# Access Compliance Report

## Public Rights-of-Way

Intersection ID: 18488	Main Street: ABBEY_PL	Cross Street: PARK_RD	Location: SE
ADA ID: 78B3B4CD2DC7	Ramp Type: PerpDiag	Initial Pass/Fail: Fail	Overall Compliance: No
		Severity Score: 25

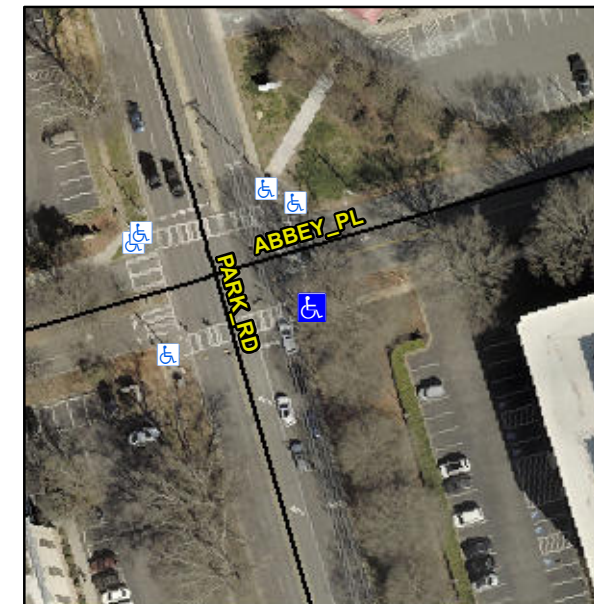
**Not Found, R304.2.2**

Compliance	Description	Data	Compliance	Description	Data
N/A	Ramp Length (in)	84.0	No	Ramp Slope (%)	15.7
Yes	Ramp Width (in)	54.0	Yes	Ramp XSlope (%)	0.8
N/A	Flare Type LT	N/A	N/A	Flare Type RT	N/A
N/A	Flare Slope LT (%)	N/A	N/A	Flare Slope RT (%)	N/A
N/A	Flare Traversable LT?	N/A	N/A	Flare Traversable RT?	N/A
N/A	Landing Length (in)	N/A	N/A	DWS Provided?	N/A
N/A	Landing Width (in)	N/A	N/A	DWS Contrast?	N/A
N/A	Landing Slope (%)	N/A	N/A	DWS Length (in)	N/A
N/A	Landing X Slope (%)	N/A	N/A	DWS Full Width?	N/A
N/A	Landing Curb? (Y/N)	N/A	N/A	DWS Offset (in)	N/A
N/A	Shared Landing?	N/A			
N/A	Gutter Ponding?	N/A	N/A	Gutter Slope (%)	N/A
N/A	Gutter Lip Ht (in)	N/A	N/A	Gutter X Slope (%)	N/A
N/A	Painted X Walk1?	Yes	N/A	Painted X Walk2?	Yes
	X Walk 1 Direction	To N		X Walk 2 Direction	To W
N/A	X Walk 1 Width (in)	110.0	N/A	X Walk 2 Width (in)	96.0
	X Walk 1 Slope (%)	3.3		X Walk 2 Slope (%)	3.7
	X Walk 1 X Slope (%)	2.9		X Walk 2 X Slope (%)	3.8

**Remove & Replace Curb Ramp With Two New Directional Ramps or Equivalent. Restripe Crosswalk.**
